This is an ODOT let project. The project name in the plans shall match the project name in Ellis:
BUT GMR Trail Middletown-Monroe

GREAT MIAMI RIVER TRAIL

COVER SHEET	P.1
SCHEMATIC PLAN	P.2
TYPICAL SECTIONS	P.3
GENERAL NOTES	P.4
GENERAL SUMMARY	P.5
PLAN AND PROFILE	P.6-P.24
CROSS SECTIONS	P.25-P.69

119064

P.8

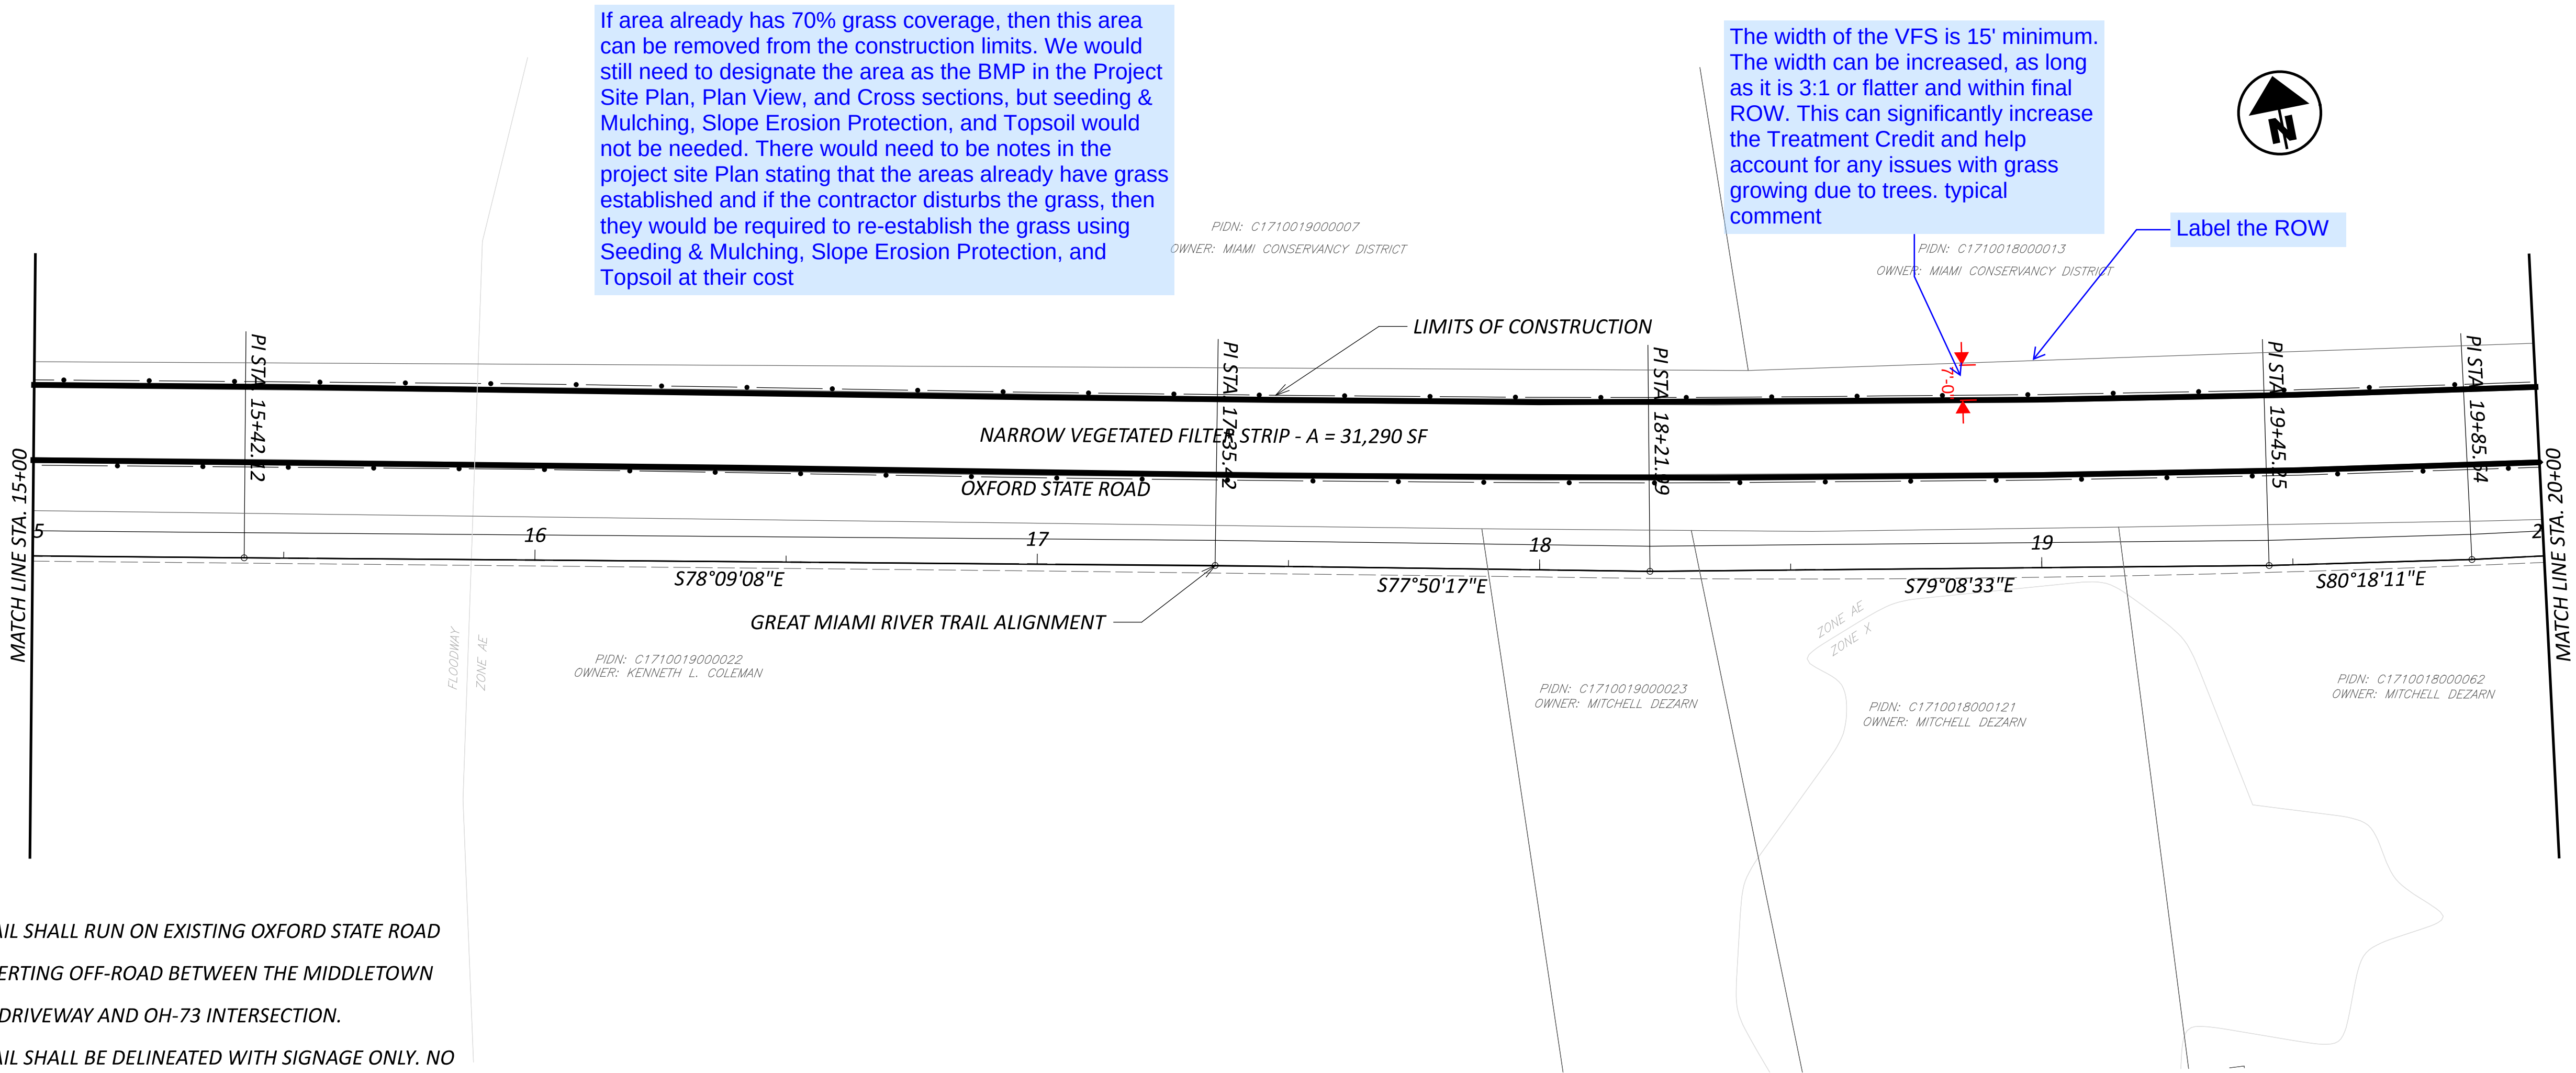
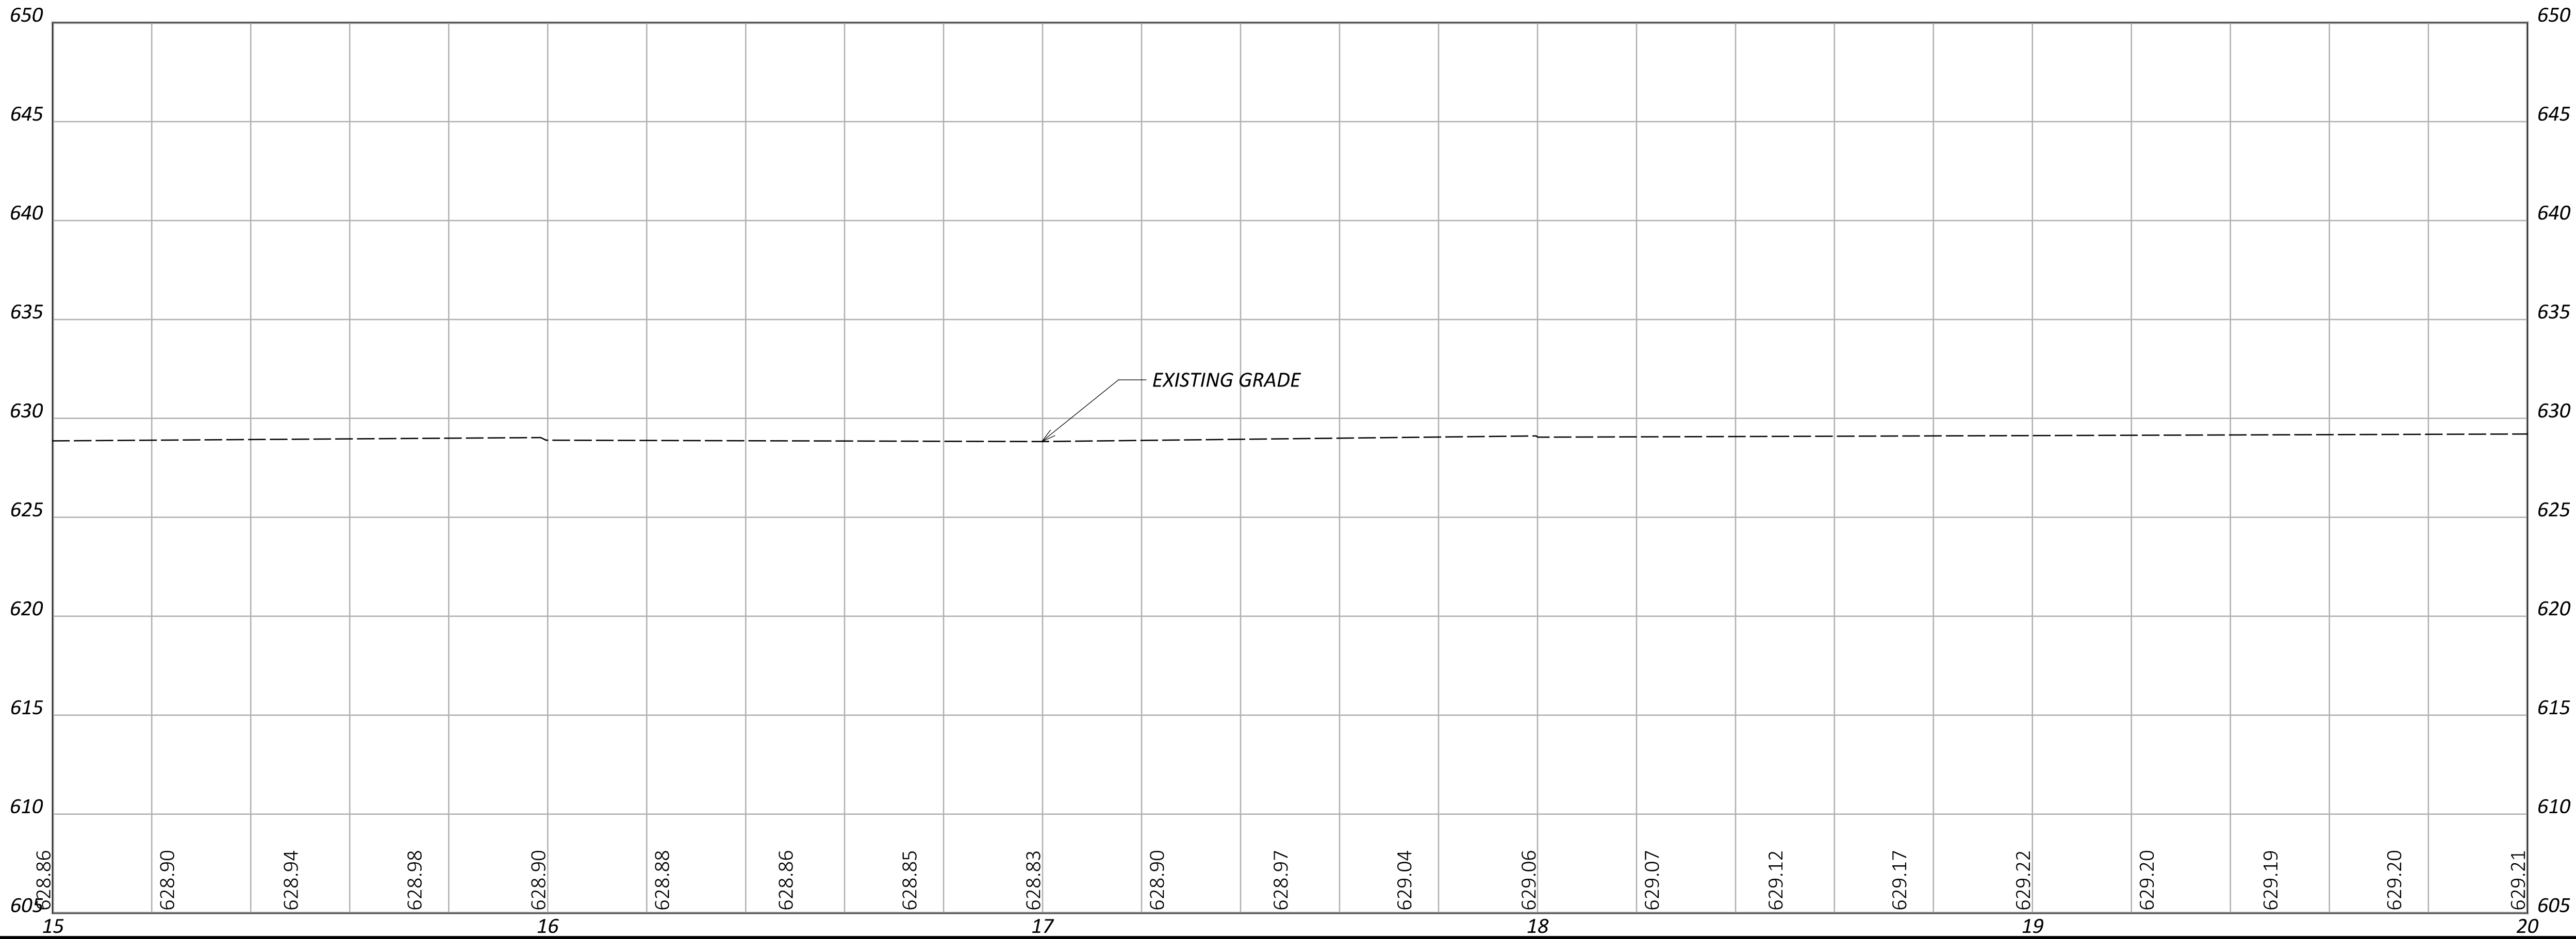
If area already has 70% grass coverage, then this area can be removed from the construction limits. We would still need to designate the area as the BMP in the Project Site Plan, Plan View, and Cross sections, but seeding & Mulching, Slope Erosion Protection, and Topsoil would not be needed. There would need to be notes in the project site Plan stating that the areas already have grass established and if the contractor disturbs the grass, then they would be required to re-establish the grass using Seeding & Mulching, Slope Erosion Protection, and Topsoil at their cost

The width of the VFS is 15' minimum. The width can be increased, as long as it is 3:1 or flatter and within final ROW. This can significantly increase the Treatment Credit and help account for any issues with grass growing due to trees. typical comment

P.19

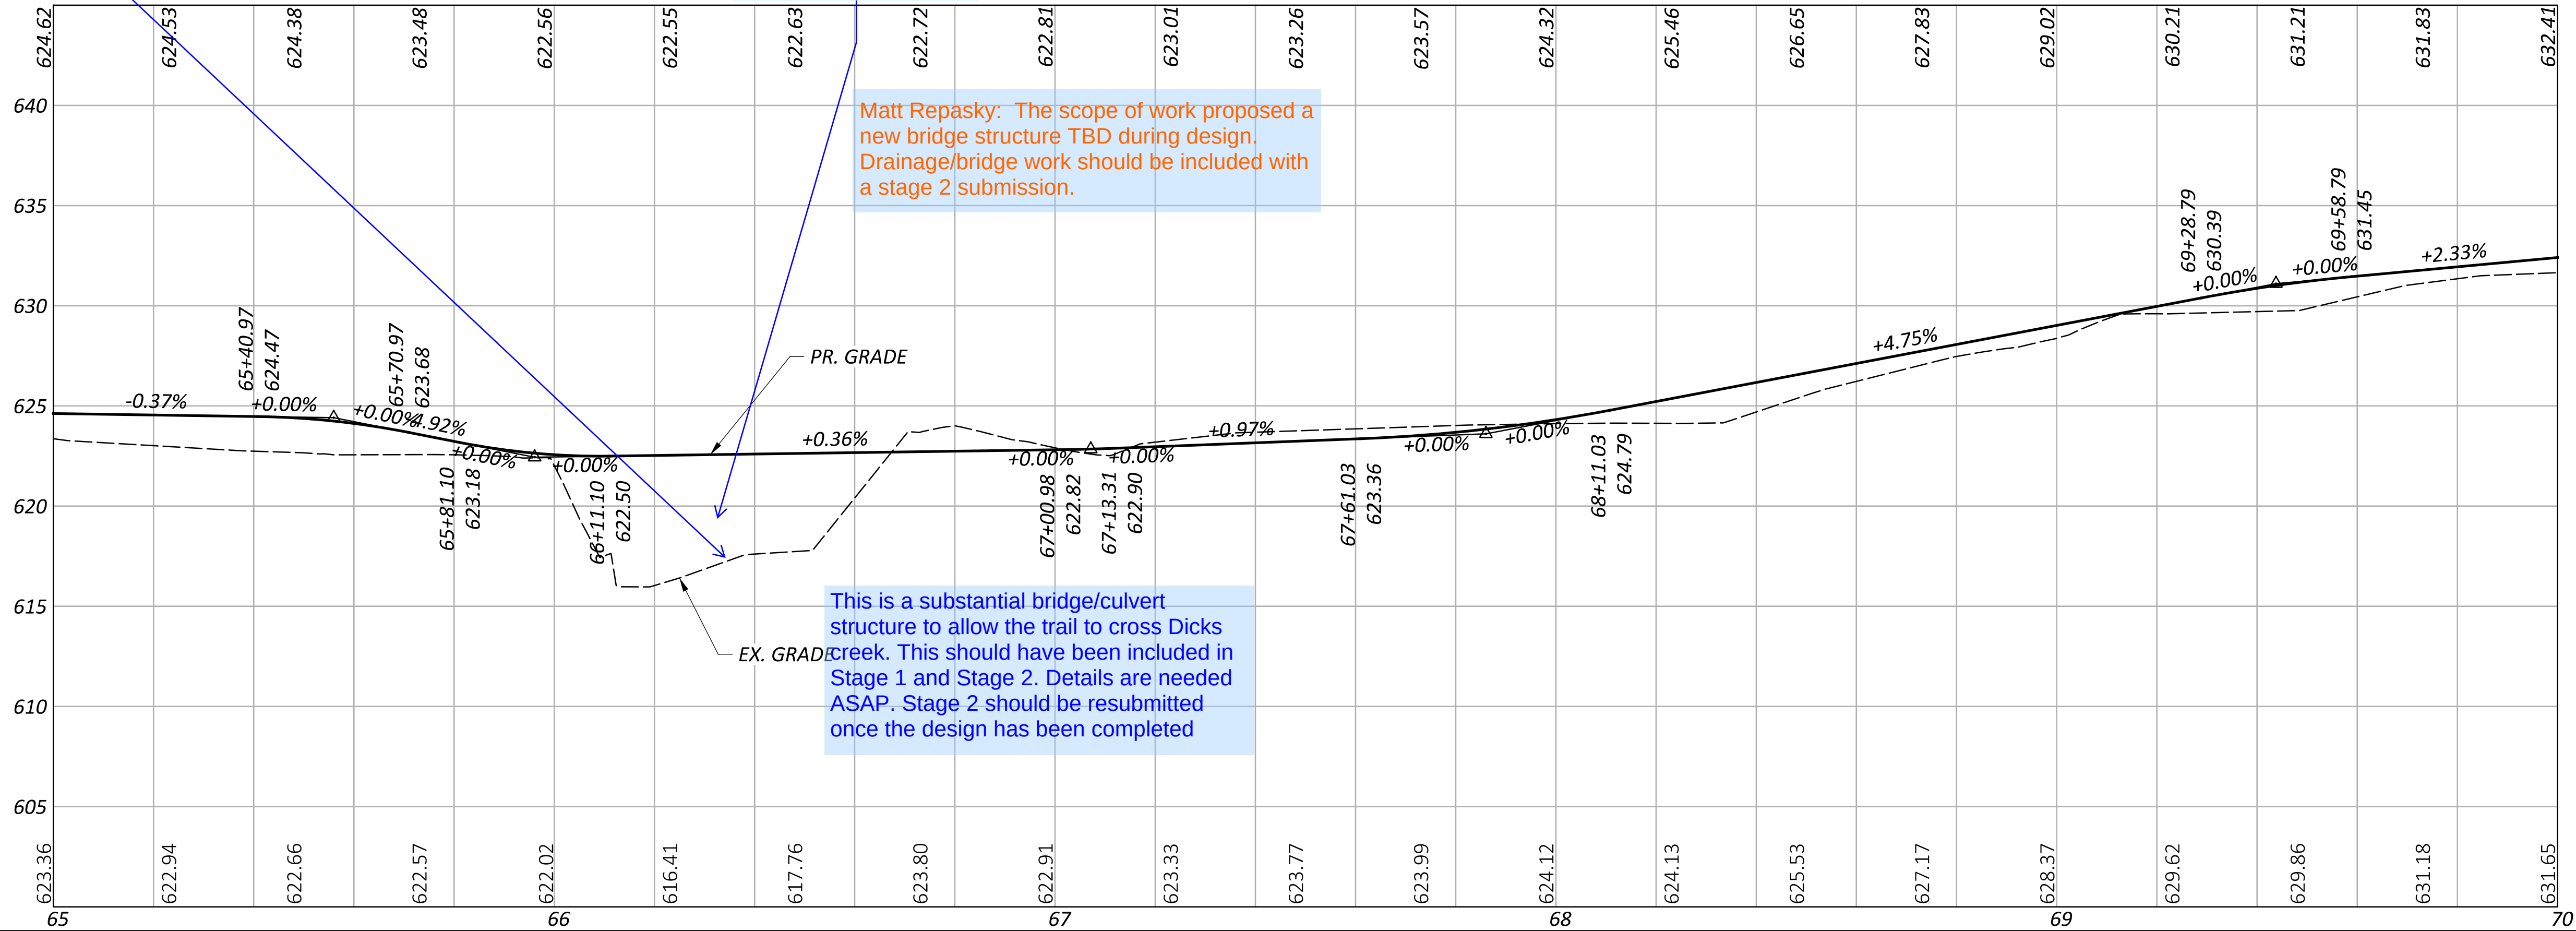
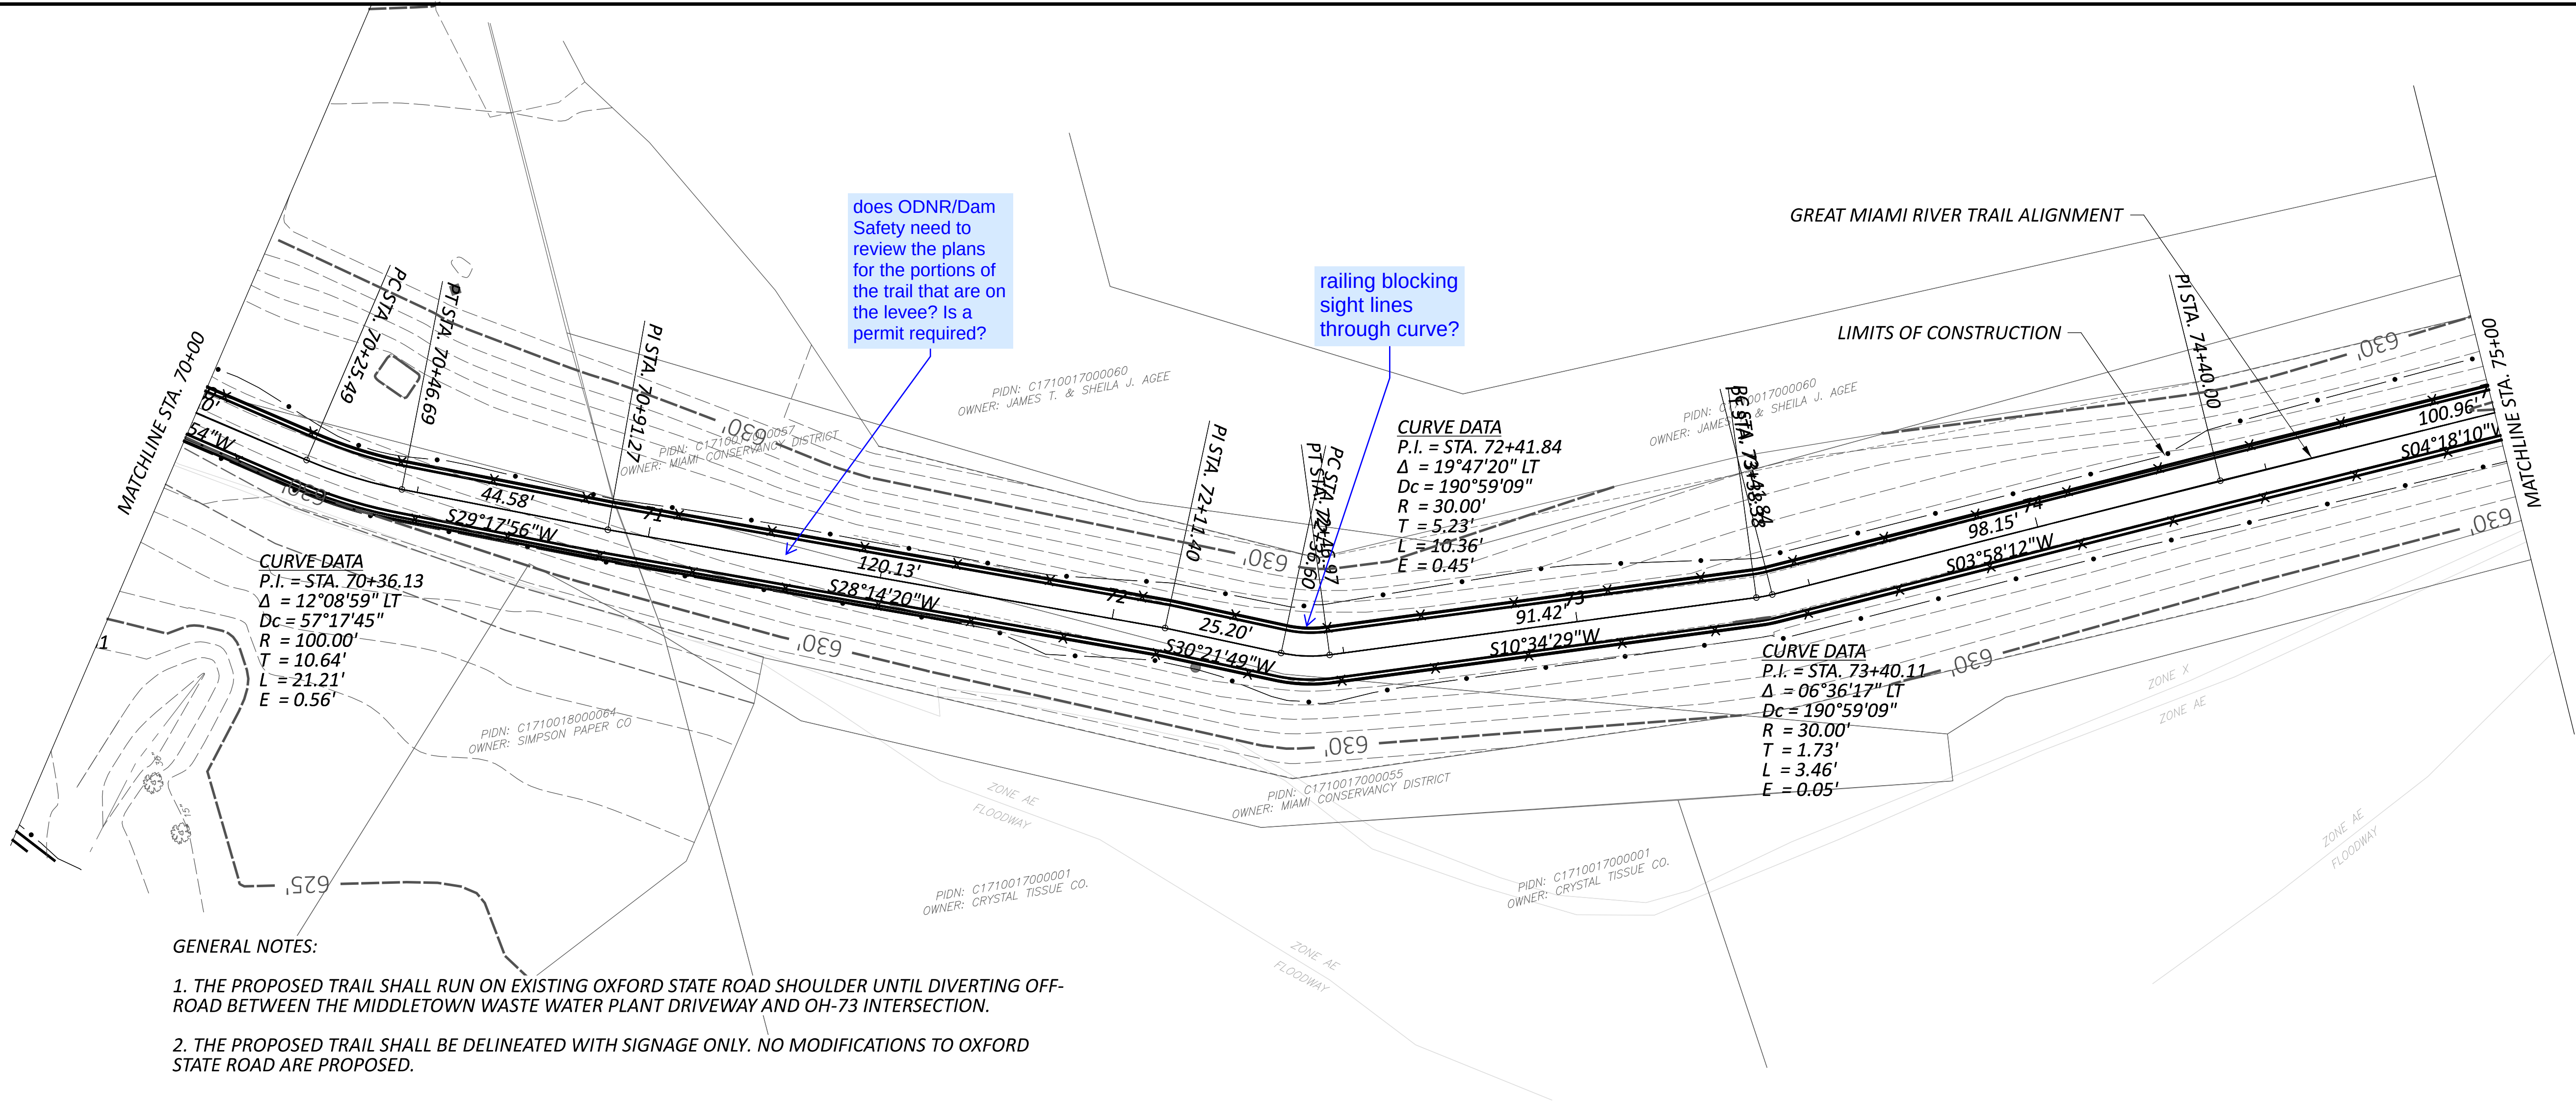
Curve warning signs needed

Dick's Creek to be labeled
OHWM to be added

Are these culverts to be constructed with this path?
If so, details/info are missing from this submittal.

Matt Repasky: The scope of work proposed a new bridge structure TBD during design. Drainage/bridge work should be included with a stage 2 submission.

This is a substantial bridge/culvert structure to allow the trail to cross Dicks creek. This should have been included in Stage 1 and Stage 2. Details are needed ASAP. Stage 2 should be resubmitted once the design has been completed
